Re: Meadow Way Bridge

RE Public Hearing, agenda item 13 at May 6, 21020 Town Council meeting:

RE: Request for an Environmental Impact Report (EIR) for the Meadow Way Bridge replacement project and channelization of San Anselmo Creek

ATTACHMENT 1

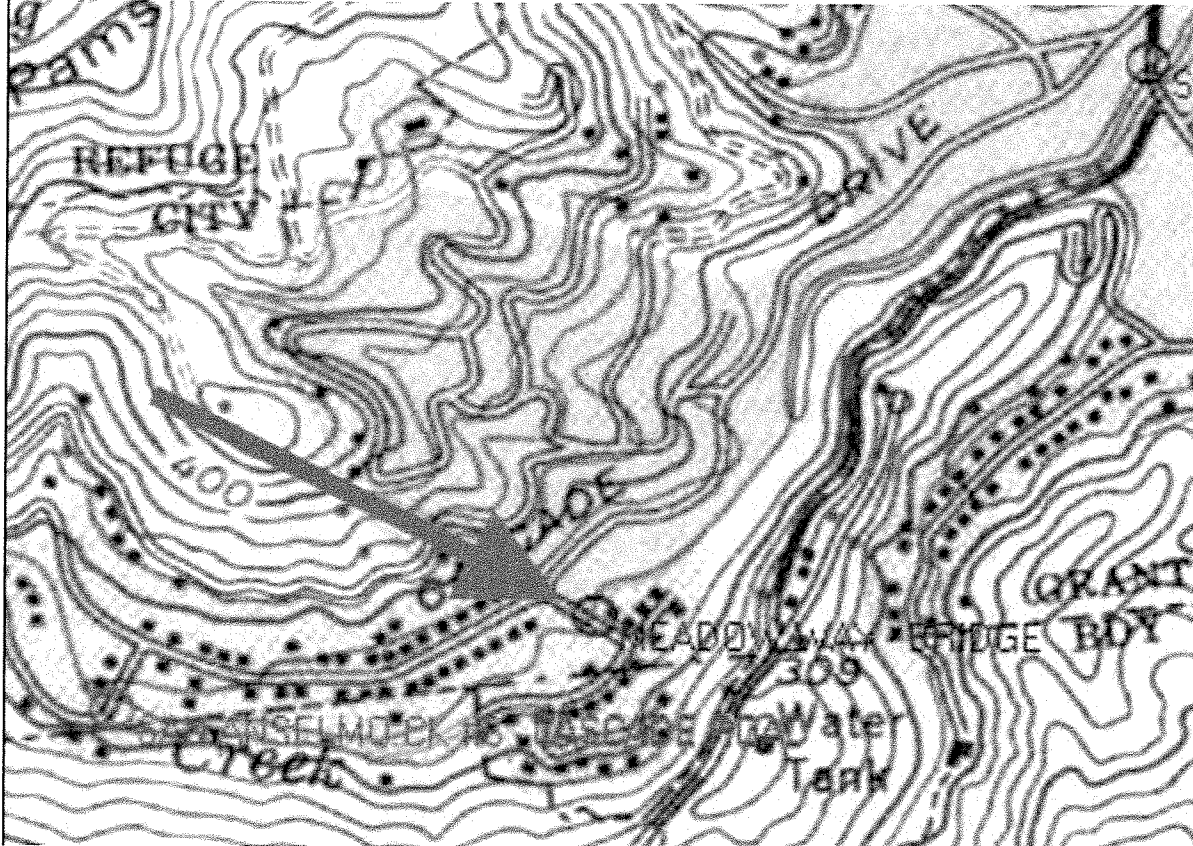
US QUADRANGLE DETAIL SHOWS SAN ANSELMO CREEK AT MEADOW WAY BRIDGE TO BE A PERENNIAL CREEK.

ATTACHMENT 2

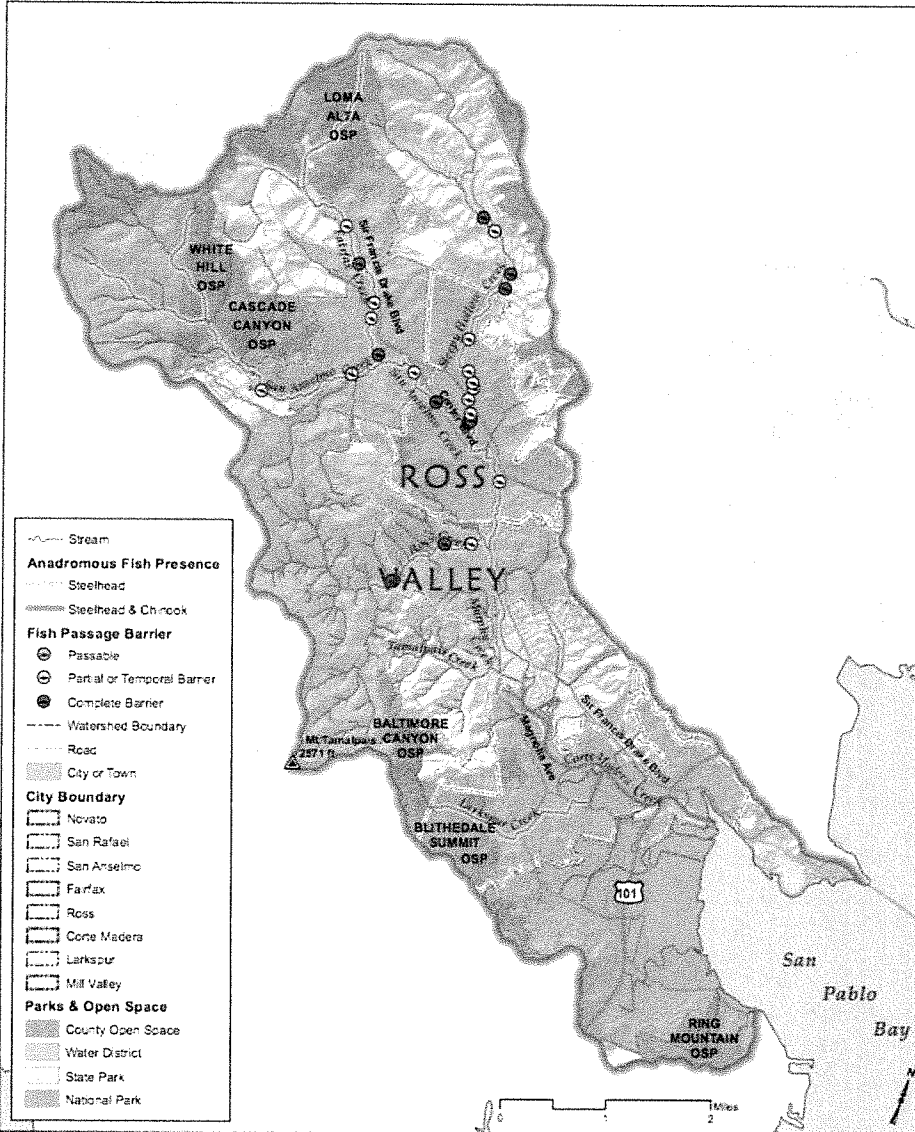
- The Meadow Way reach of San Anselmo creek is officially a perennial creek and not an intermittent creek as stated in the Initial Study and MND. Attached are multiple maps and definitions that verify this perennial creek status including those provided in the Sierra Club letter, USGS, National Wetlands Inventory, U.S. Geological Survey, Marin County Watershed Program, National Marine Fisheries Service (NMFS), EcoAtlas, CEMAR, Fisheries Biologist Alice Rich, etc. (multiple examples below in Attachments 1-5). The following definitions are pertinent:
